**Subject: Notice of Violation No. R9-2014-0018, Casa Mira View,  
NPDES Order No. 2009-0009-DWQ, Statewide Construction General Storm Water  
Permit**

**NOTICE OF VIOLATION  
No. R9-2014-0018**

**FACILITY INSPECTION REPORT**

Facility: Casa Mira View, WDID 9 37C353628  
Inspection Date: 01/09/2014

Figure 1. Near trailer; cigarette butts

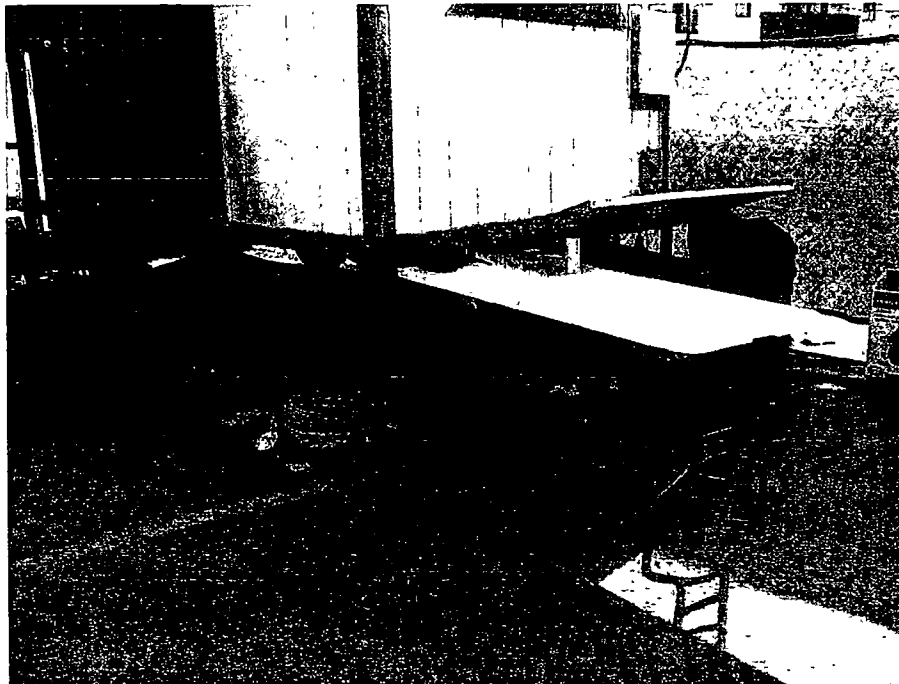
1. The site was littered with cigarette butts, trash, debris, and other construction-related waste throughout. (See Figures 1-4, 14-25).
2. None of the finished curbs within the site had sediment control BMPs (such as silt fence) installed. As a result, the streets were covered in sediment (Figures 1, 3, 16-22).
3. There were no sediment control BMPs at one construction site exit/entrance located on Mira Lee Way, and sediment had been tracked into the street (Figure 5).
4. There was an uncovered stockpile, although it appeared to be active (Figure 6).
5. Two concrete wash-out bins were leaking, and waste material discharged to the surrounding the soil (Figures 7-8).

9. Construction debris and trash must be disposed of properly.
10. The construction site superintendents should read and understand the requirements contained within the State Water Resources Control Board Construction General Storm Water Permit, Order No. 2009-0009-DWQ (CGP).

Figure 9. Slope on north side with no erosion control

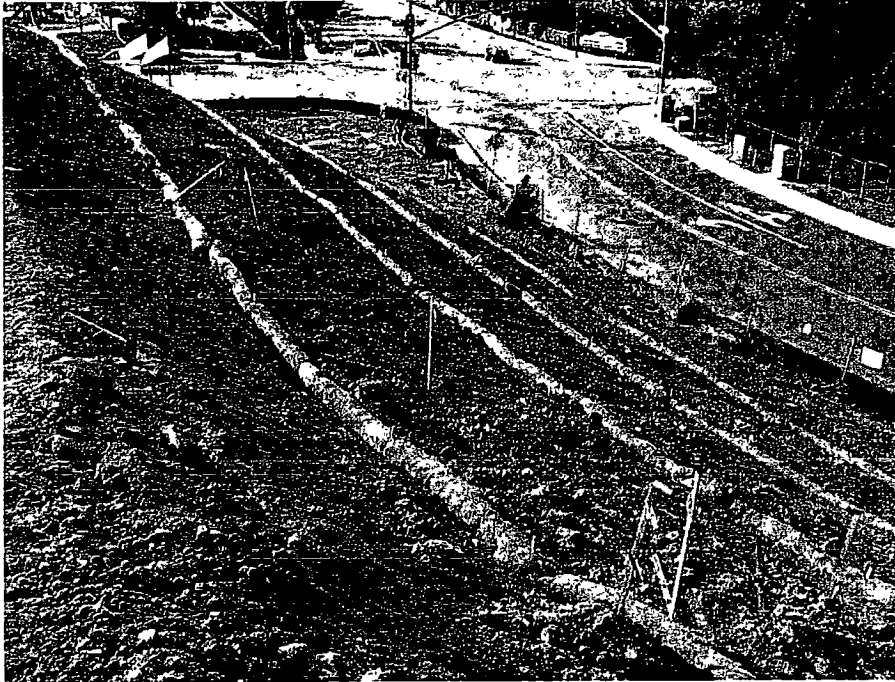
6. The site had no erosion control BMPs on exterior slopes along the north and west side of the property, 3 months into the rainy season (Figure 9-12).

1. The entire site lacks adequate sediment, erosion control, construction waste, and housekeeping BMPs.
2. The site requires erosion control BMPs on all slopes (interior and exterior), such as hydroseed, bonded fiber matrix, or erosion control blankets.

Figure 22. Broken gravel bags

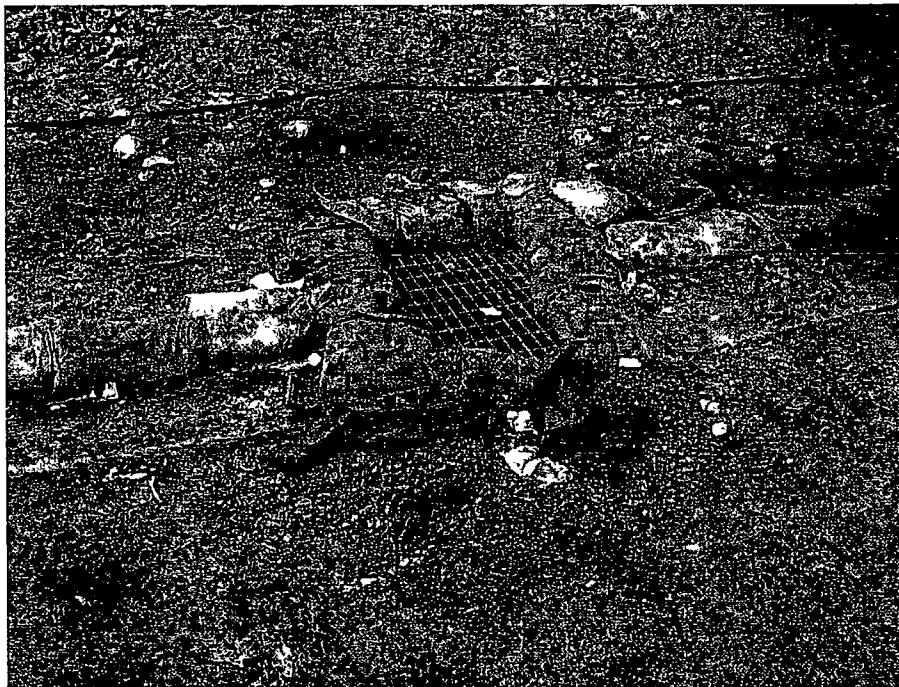
7. The silt fence along the north side of the property had fallen and was in need of repair (Figure 13).
8. Sediment control BMPs throughout the site need replacement or had not been maintained. Examples include broken gravel bags (Figure 22).

7. Storm drain inlets within the construction site require protection to prevent sediment, trash, and construction debris from entering.
8. Gravel bags that have been broken need replacing.

Figure 24. Storm drain littered with construction debris

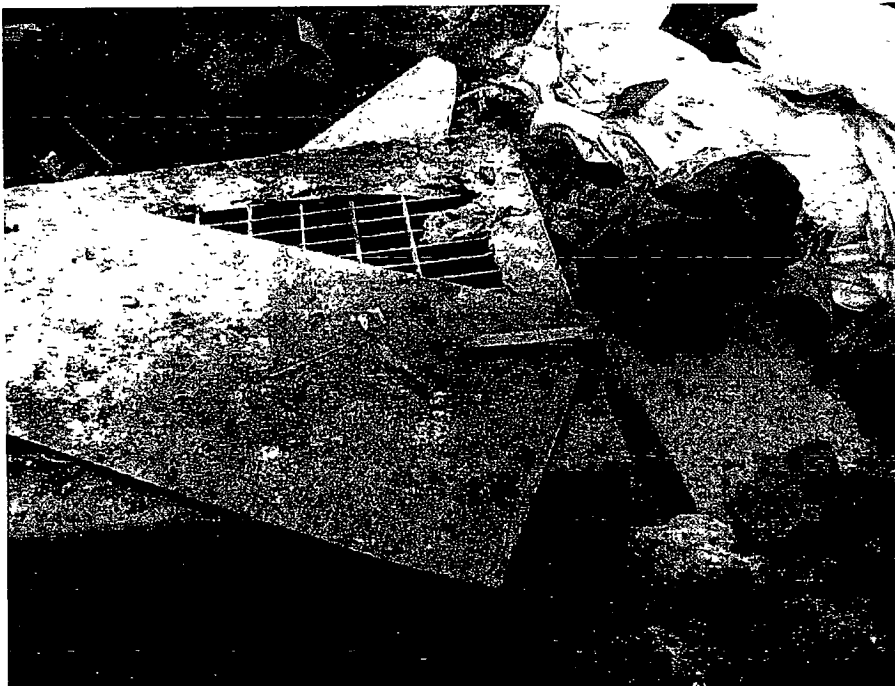
9. Mortar mix and other construction wastes had entered an unprotected inlet (Figures 23-24).
10. Several chemical containers were found throughout the site without secondary containment or other proper storage practices (Figure 25).

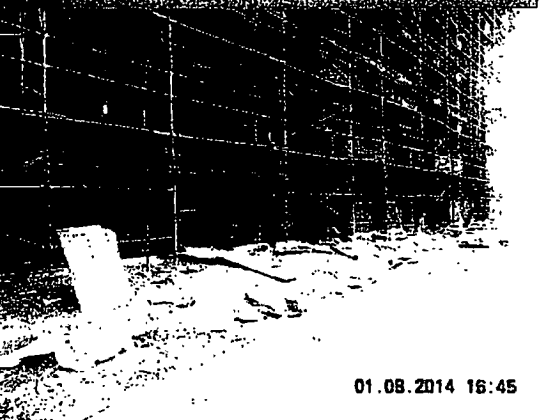
ITEM	Inspection Observation and Corrective Actions Summary	Assigned to	Date Completed
13	13. Maintain existing Inlet protection.		
Response:			
17	17. Sweep tracking as needed. Visually inspect daily.		
Response:			
18	18. Properly dispose of construction debris/trash.		
Response:			
0			
Response:			
0			
Response:			
0			
Response:			
0			
Response:			
0			
Response:

Figure 3. Site interior; inlet requires better protection

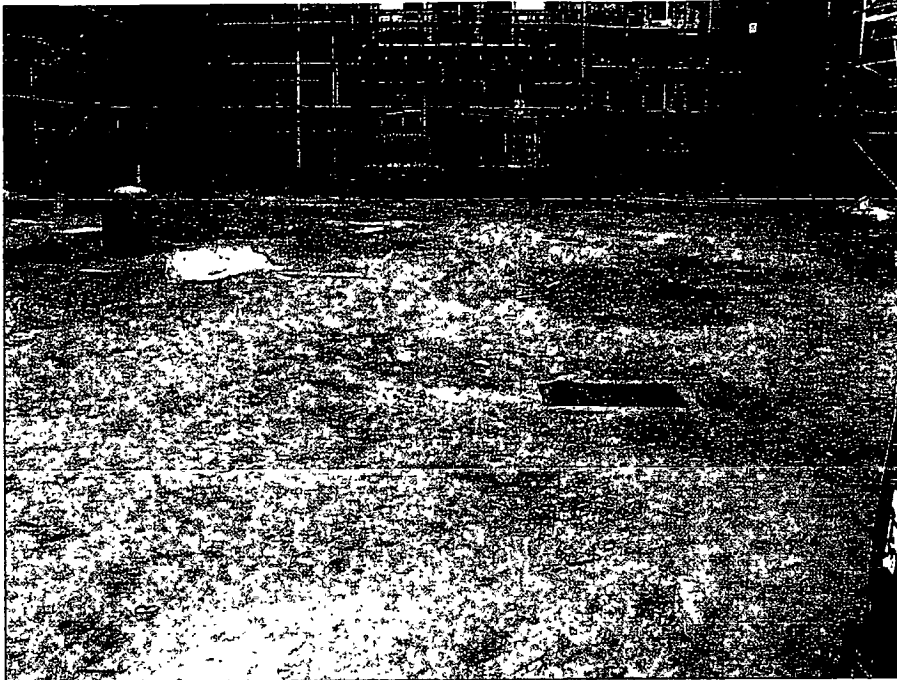
1. The finished roads within the site have been swept and are much cleaner than the previous site visit (Figures 1-2, 4).
2. One storm drain on the east side requires improved protection (Figure 3).
3. Sandbags had been replaced; however, additional BMPs are needed to prevent sediment from reaching the street (Figure 5).
4. A trash bin was overflowing (Figure 7).
5. Cigarettes in front of the trailers had been swept (Figure 8).
6. The leaking concrete wash-out bins were replaced or fixed (Figure 9).
7. The exterior slopes had adequate erosion control BMPs (Figures 10-11).

Figure 14. Looking north into construction site from entrance in Fig. 13

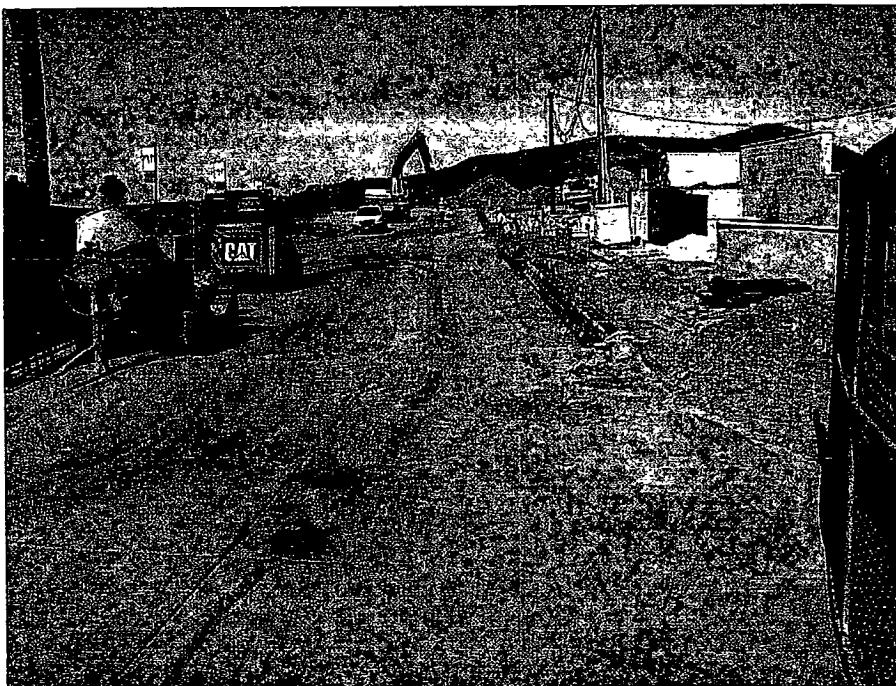
8. Chemical containers had secondary containment and the site was much tidier than the previous inspection (Figure 12).
9. There were no sediment control BMPs at one construction site exit/entrance located on Mira Lee Way, and sediment had been tracked into the street (Figures 13-14). Site operators indicated that this area is swept; however, a structural BMP such as gravel or shaker plates should be considered since street sweeping does not occur daily.
10. We found some fiber rolls that could be used in the event of rain; however, overall the site contains inadequate stockpiled BMPs. Mr. Melbourn asked that the site operators produce a list of stockpiled BMPs within two weeks.
